UNITED STATES PATENT AND TRADEMARK OFFICE

APPLICATION NO.	FILING DATE	FIRST NAMED INVENTOR	ATTORNEY DOCKET NO.	CONFIRMATION NO.
10/584,920	12/28/2006	Philip J. Simpson	ICUMM.376A	1318

Office Action Summary	Application No. 10/584,920	Applicant(s) SIMPSON ET AL.	
	Examiner KAMI A. BOSWORTH	Art Unit 3767

DETAILED ACTION

Fig A

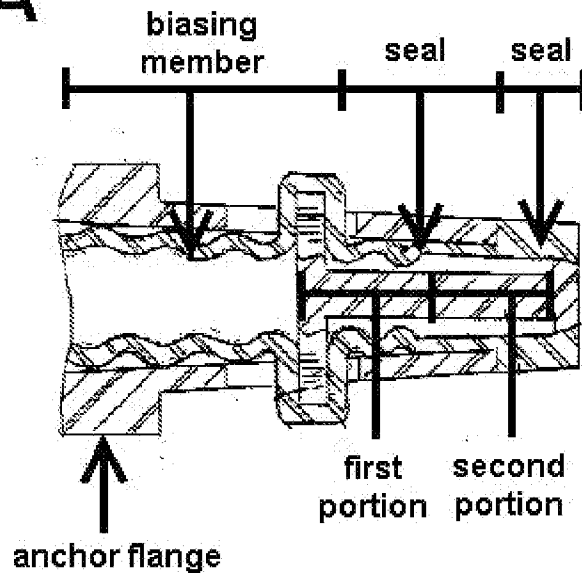
5. Re claim 1, Doyle discloses a valved male luer medical connector 10 (Fig 1) comprising: a male luer portion 104 (Fig 22; equivalent to male luer portion 16 in Fig 1) in a distal side of the connector, the male luer portion comprising interior and exterior surfaces and a bore extending between the interior and exterior surfaces (as seen in Fig 22), a female luer end portion (as seen in Fig 1) in a proximal side of the connector and a channel 124 (Fig 22) for the transfer of fluids between the male luer portion and the female luer end portion (Para 50), a valve member 154 (Fig 22) movable between a closed position (as seen in Fig 22) and an open position (as seen in Fig 23), the valve member comprising a proximal first portion (best seen in Fig A below) and a second portion (best seen in Fig A below) distal from the first portion, the first and second portions of the valve member being configured to move generally longitudinally between the closed and open positions such that a proximal end of the first portion is positioned closer to the female luer end portion in the open position than in the closed position (as seen in Fig 22,23; Para 50), the second portion being positioned at least partially within the male luer portion (as best seen in Fig A below) in the closed position, the valve member further comprising a plug portion 160 (Fig 22) distal from the second portion, the plug portion having a distal end (as seen in Fig 22), the plug portion being closed-ended on the distal end thereof in both the open and closed positions such that fluid is prevented from flowing through the distal end of the plug portion in both the open and closed positions (as seen in Fig 22,23; Para 50), and the plug portion being configured

to engage the interior surface of the male luer portion to form a seal such that the closed end of the plug portion is generally flush with a distal end of the exterior surface of the male luer portion in the closed position (as seen in Fig 22), a seal (portion of 160 distal to flange 156; best seen in Fig 22 and A below) extending generally around a portion of the second portion of the valve member (as seen in Fig A below), a biasing member (portion of 160 proximal to flange 156; best seen in Fig 22 and A below) configured to bias the valve member toward the closed position (Para 50), at least a portion of the biasing member generally surrounding at least a portion of the first proximal portion of the valve member (as seen in Fig A below), and an actuating member 158 (Fig 22) extending distally into a region near the exterior surface of the male luer portion in the closed position (as seen in Fig 22), the actuating member being fixed to and unitary with the valve member (as seen in Fig 22), and the actuating member being configured to actuate the valve member from the closed to the open position when a female luer end portion of a medical accessory is advanced into the distal side of the connector such that fluid is permitted to flow around the closed distal end of the plug portion and through the bore extending between the interior and exterior surfaces of the male luer portion in the open position (Para 50), and wherein the actuating member, the first proximal portion of the valve member, and the second portion of the valve member are configured to be non-deformable upon contact with the female luer end portion of the medical accessory (Para 50; as seen in Fig 7). Within this embodiment, Doyle teaches that the valve member is discrete and non-unitary with the biasing member and the seal, but does not teach that the valve all three are discrete

8. Re claim 7, Doyle discloses a housing portion 102 (as seen in Fig 14), wherein the valve member includes an anchor flange (best seen in Fig A above) extending outwardly toward an inner surface of the housing portion (as seen in Fig 14).

22. Re claim 41, Doyle discloses a second seal positioned near the first proximal portion of the valve member (as seen in Fig A above).
